EXPEDITED
MONTGOMERY COUNTY HISTORIC PRESERVATION COMMISSION
STAFF REPORT

Address:	7204 Connecticut Ave., Chevy Chase	Meeting Date:	10/10/2018
Resource:	Individually Listed Master Plan Site Constantine Lozupone House	Report Date:	10/3/2018
Applicant:	Frances Burden & William Pate	Public Notice:	9/26/2018
Review:	HAWP	Tax Credit:	No
Case Number:	35/108-18A	Staff:	Dan Bruechert
PROPOSAL:	Exhaust Vent Installation

<p>SOUTH ELEVATION</p> <p>3 / 16" = 1' - 0"</p>	<p>9/6/2018</p>	<p>BURDEN-PATE RESIDENCE 7204 Connecticut Ave, Chevy Chase, MD .20815</p>
--	---	-----------------	--

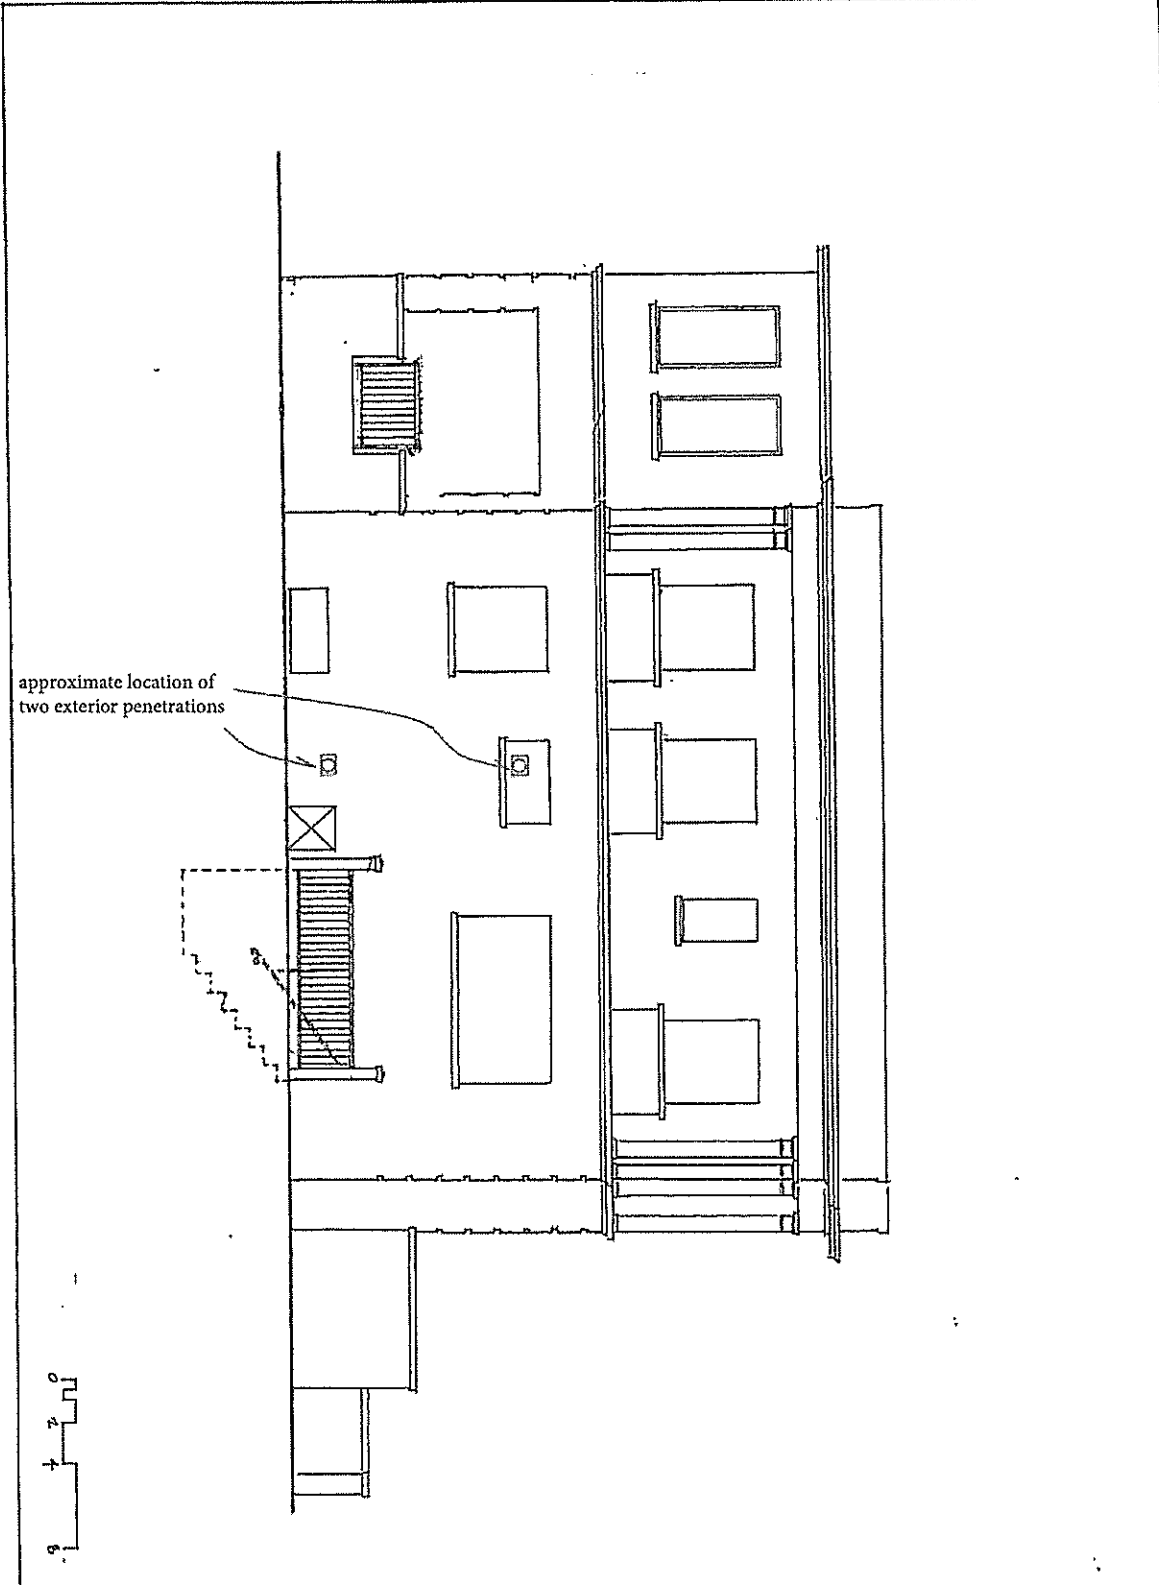
Staff recommends that the Commission **approve** the HAWP application under the Criteria for Issuance in Chapter 24A-8(b), (1), (2) & (3) having found that the proposal is consistent with the Secretary of the Interior’s Standards for Rehabilitation (specifically, Standards 2 and 5), and therefore will not substantially alter the exterior features of the historic resource and is compatible in character with the district and the purposes of Chapter 24A; and with the general condition that the applicant shall present the **3 permit sets of drawings, if applicable to Historic Preservation Commission (HPC) staff for review and stamping** prior to submission for the Montgomery County Department of Permitting Services (DPS) building permits.
